18/8-94A 15200 Barnesville Road
Boyd's Historic District

HISTORIC PRESERVATION COMMISSION STAFF REPORT

Address: 15200 Barnesville Road	Meeting Date: 3/9/94
Resource: Boyds Historic District	Review: HAWP/Alteration
Case Number: 18/8-94A	Tax Credit: Partial
Public Notice: 2/24/94	Report Date: 3/2/94
Applicant: Roy and Frances Haaser	Staff: Nancy Witherell
PROPOSAL: Alterations	RECOMMEND: Approve with Conditions

North Elevation
Proposal I

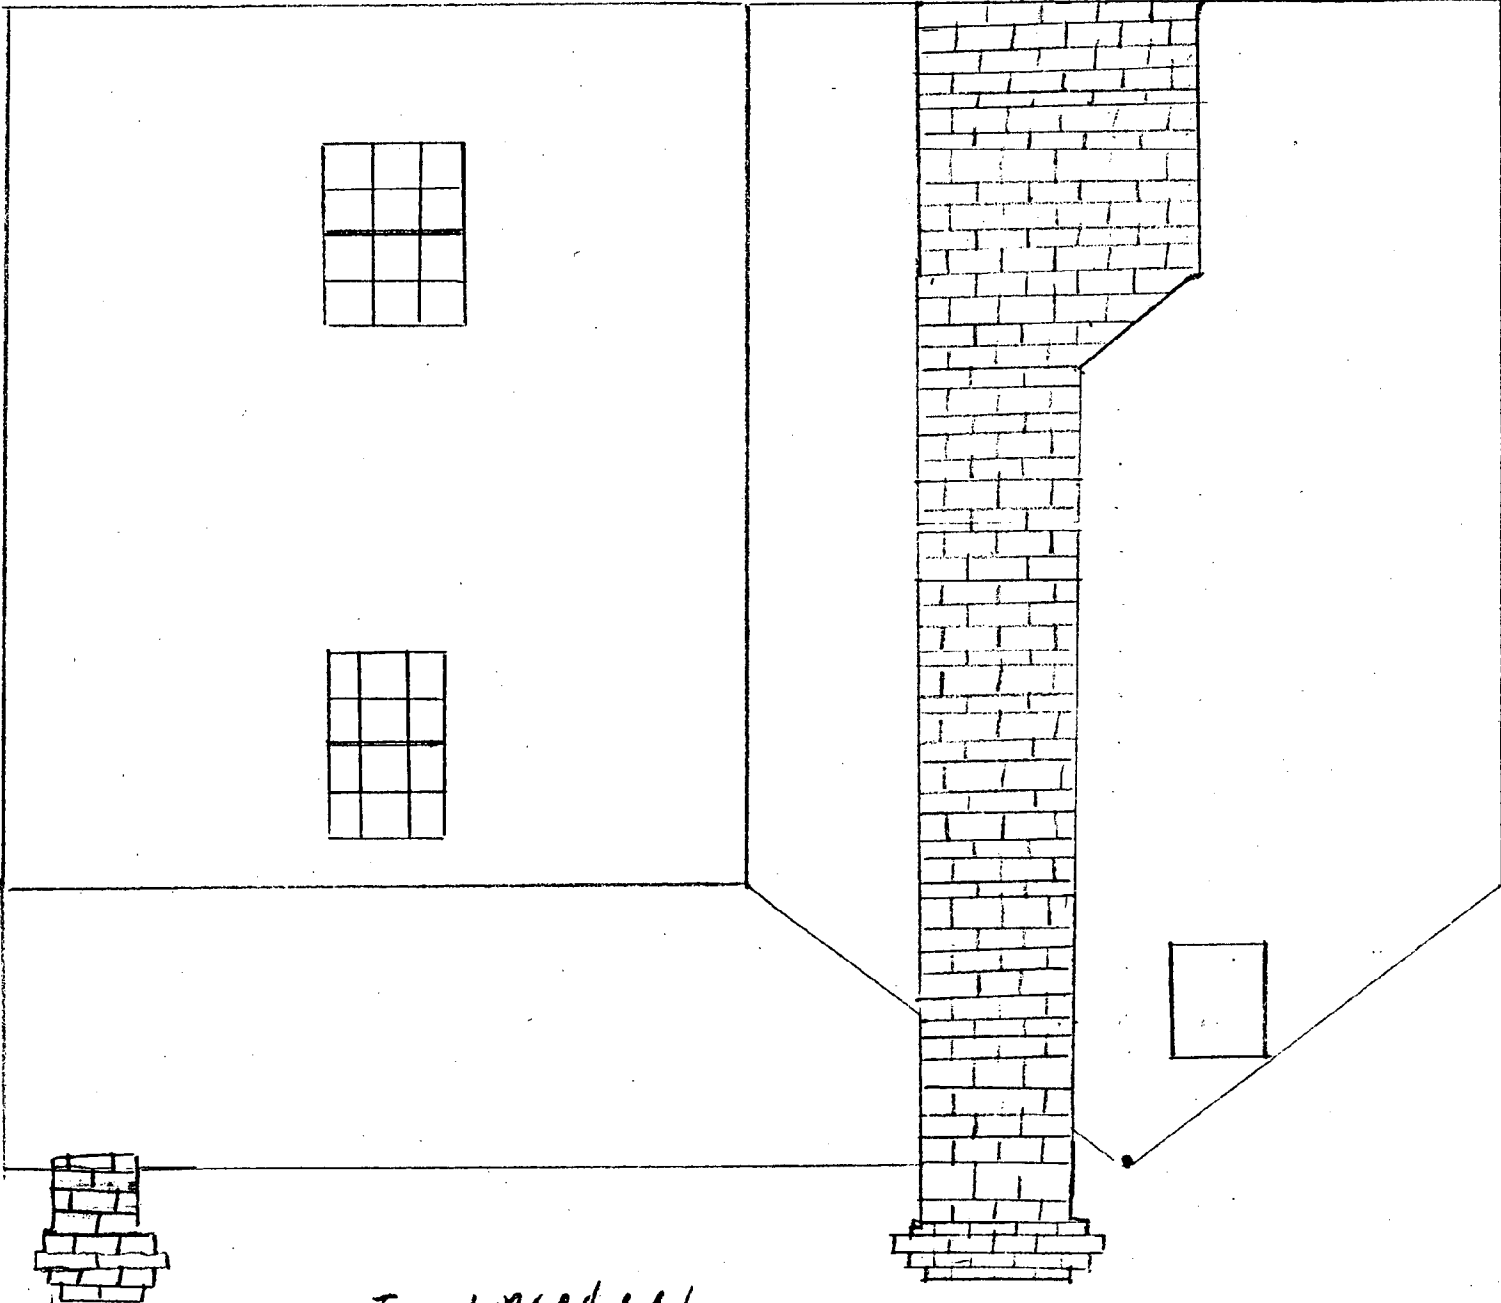
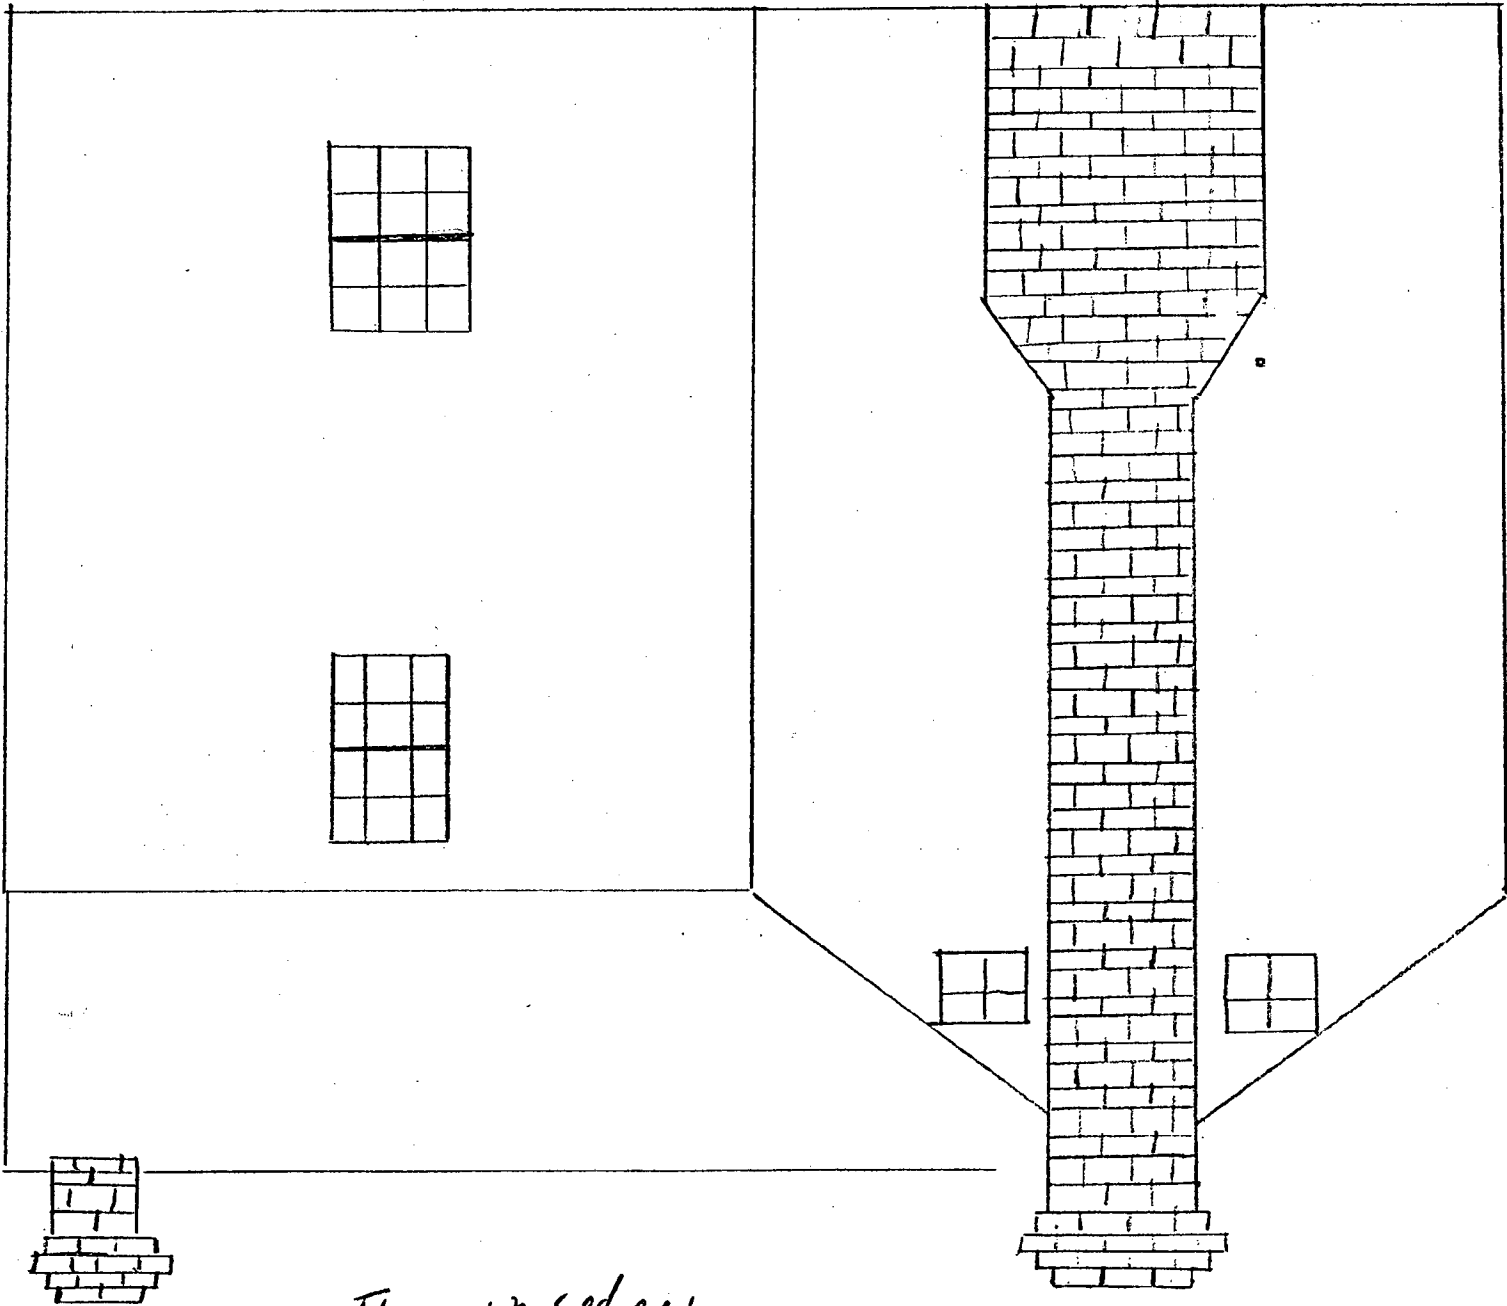
2. Remove the chimney on the north side and build a new chimney (of old brick) either centered on the roof ridge or placed about 1 1/2 feet to the rear of the center ridge.

Of these two options, the staff prefers the second, because not only will the ridge finial be lost if the chimney is centered, but the two attic windows would have to be reduced in size. Since the other gables have attic windows and the window sizes can be compared, the staff would prefer to lose a window and have the other retained rather than reduce the size of both of them. If the chimney is built of recovered brick to the extent possible, the appearance should be similar. This alteration is consistent with the ordinance, in the staff's judgment.

The staff finds the proposal consistent with the purposes of Chapter 24A, using the criteria cited below, provided the chimney is placed as discussed, the second story porch is opened and restored using matching elements, and the stained glass window is installed using either option recommended by staff.

South Elevation
(EXISTING)

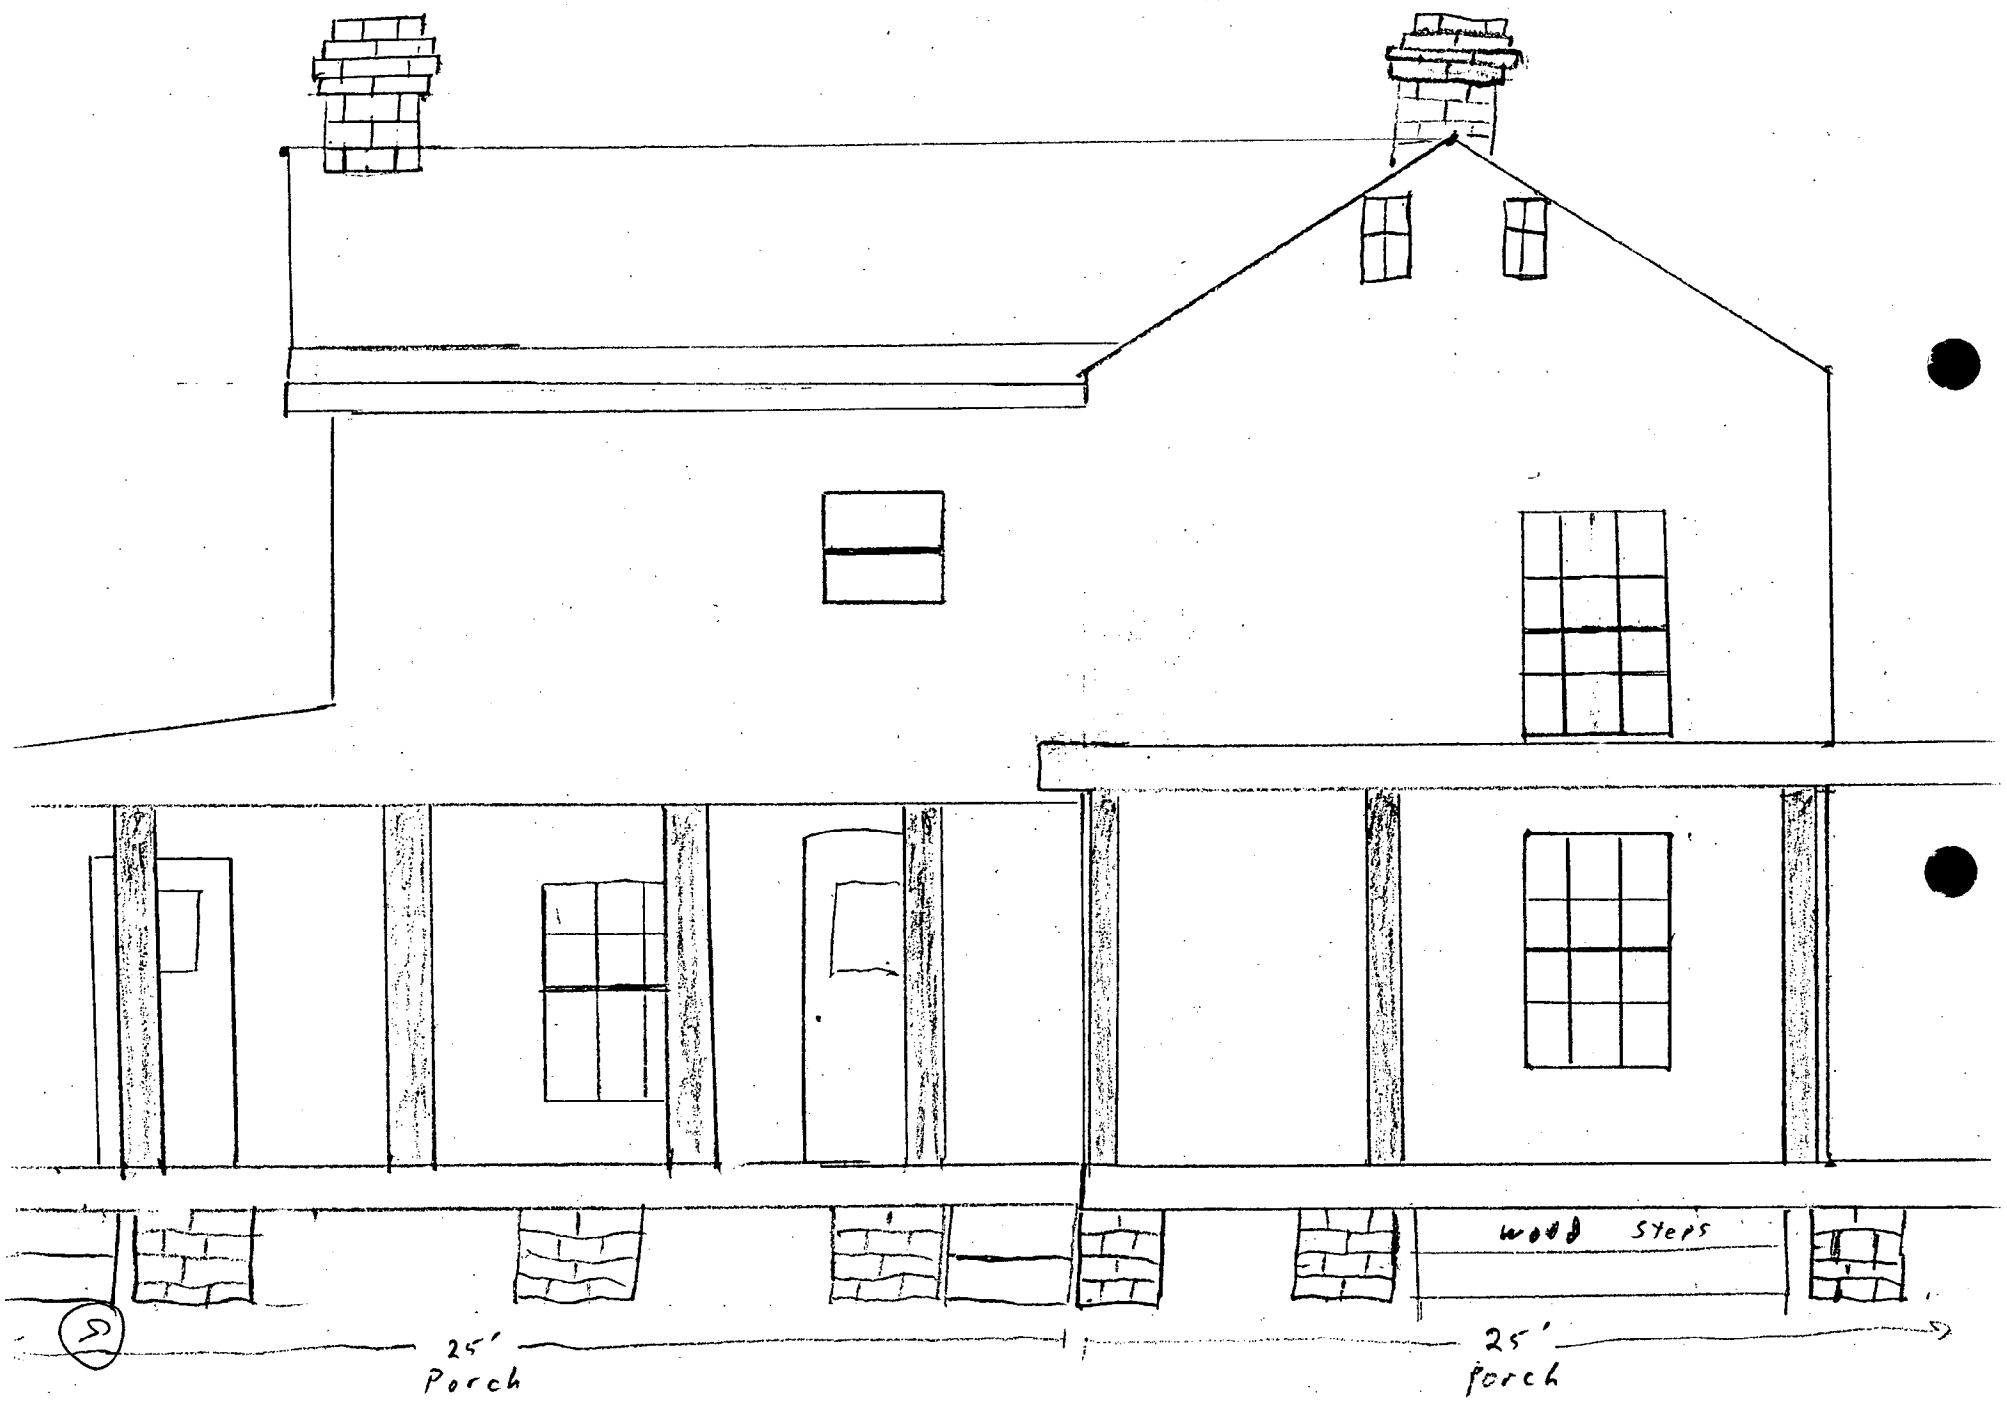
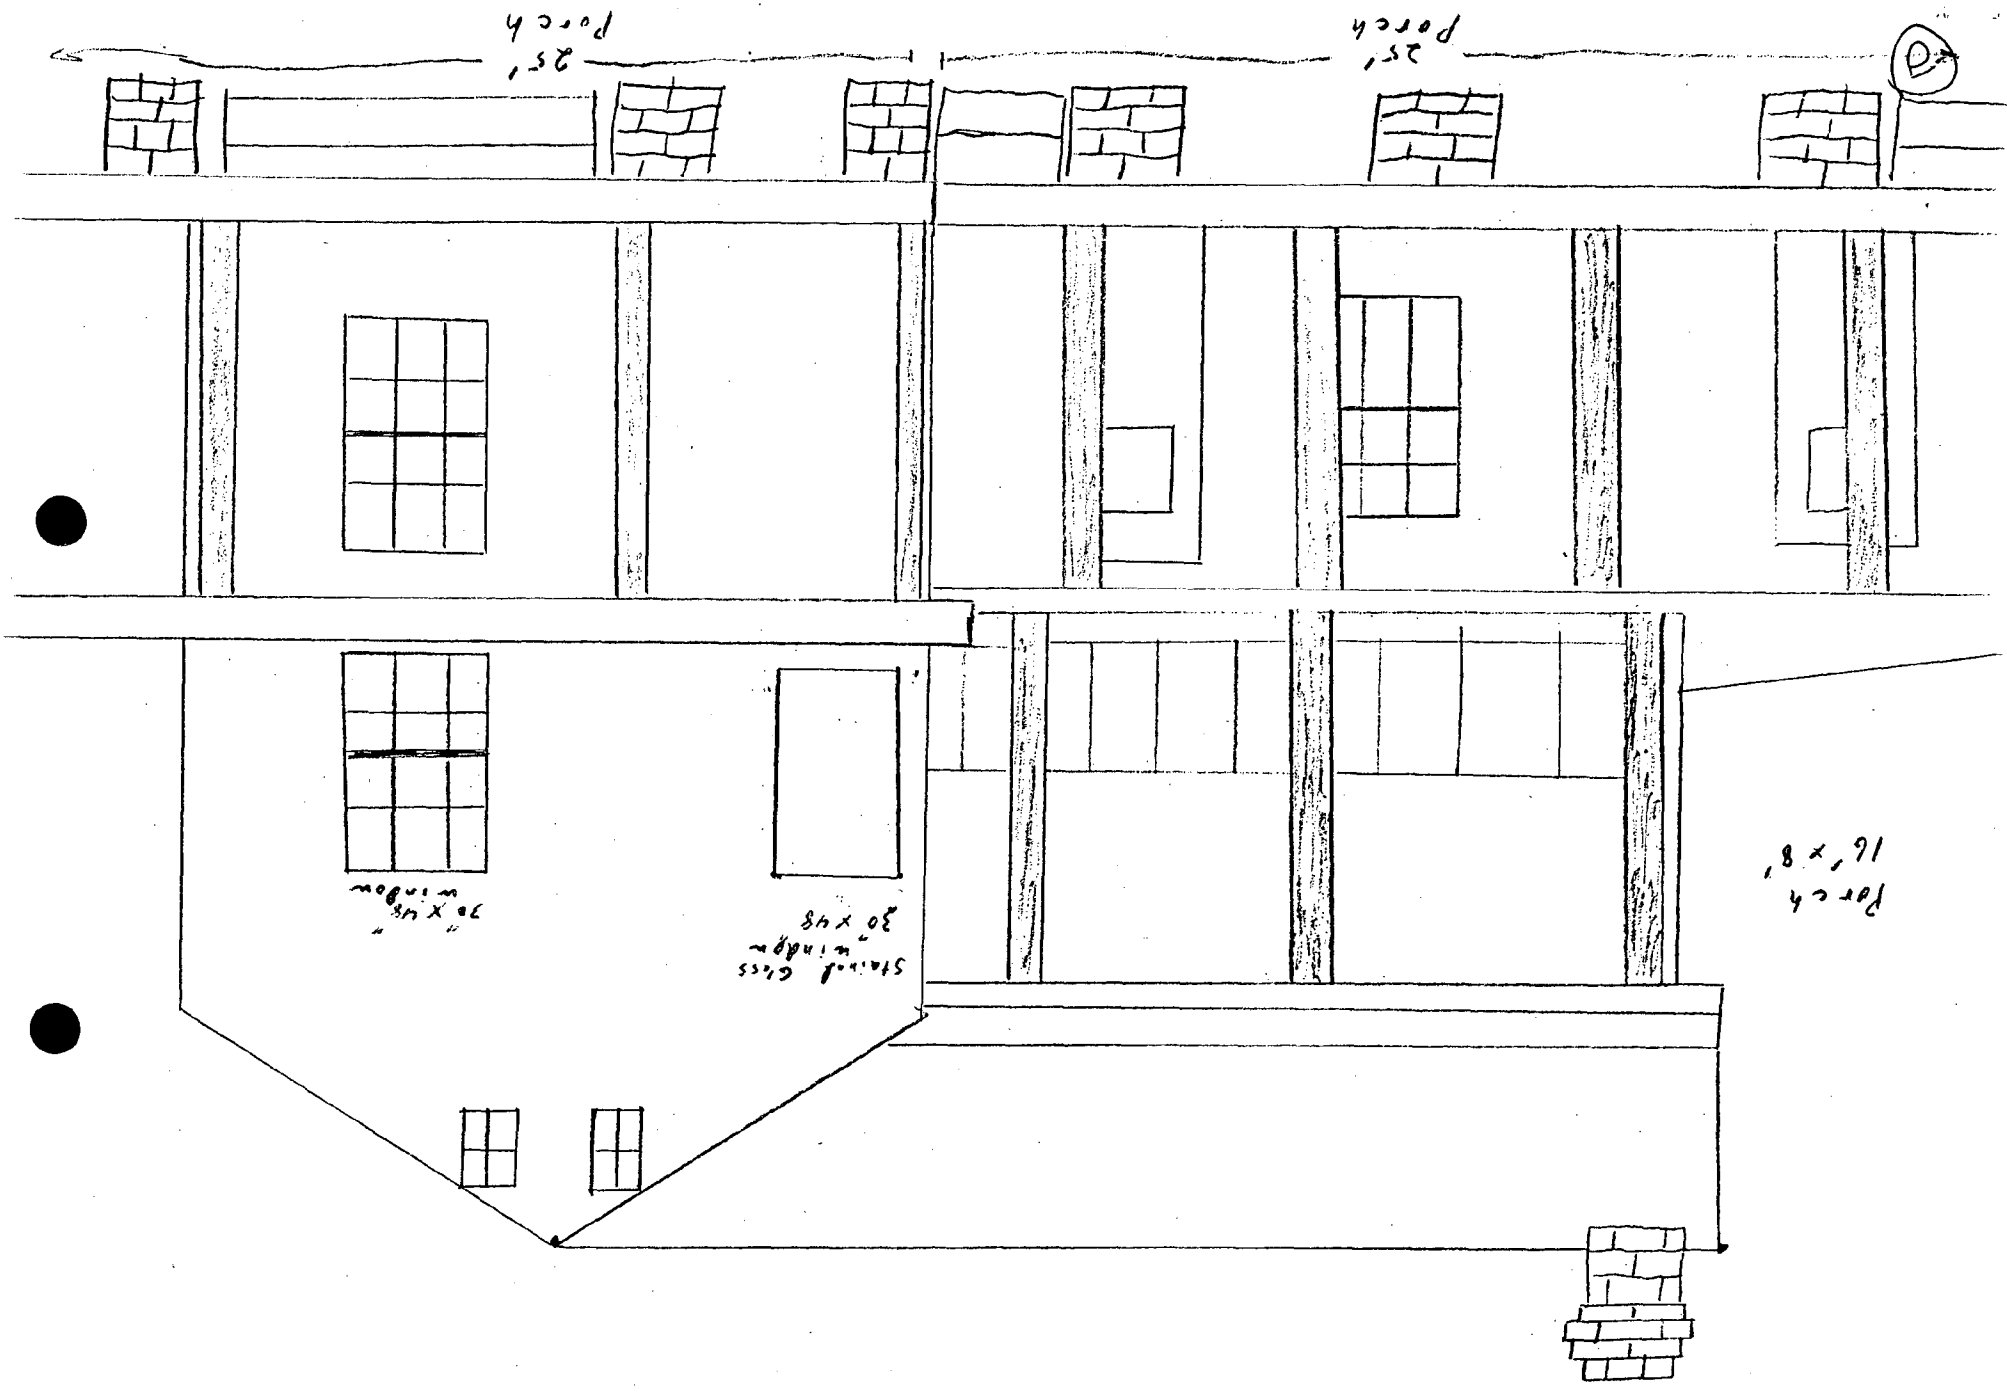
5. Create a window opening on the south elevation and install a fixed stained glass window (not yet designed) that would match the existing double-hung windows in size.

The staff suggests either of two options for this part of the project. A) Build a double-hung window with 6/6 clear glass sashes and hang or install a work of stained glass on the inside of the window. B) Create a window opening that is smaller than the others, to distinguish this window from the others, and install a square Queen Anne sash window.

The staff is concerned about the placement of the window, since it is closer to the edge of the wall than the adjacent second story window and wouldn't look symmetrically paired as it should. That argues for the second option.

The staff recommends that the Commission require that more detailed plans be submitted to the HPC staff before the HAWP is released to DEP. The plans should show details of the porch restoration and the stained glass window installation, in particular, as well as window surrounds for the new windows. The plans should also specify that new windows will match existing, that the roof repairs will match the existing, and which type of siding will be used for the new exterior porch wall.
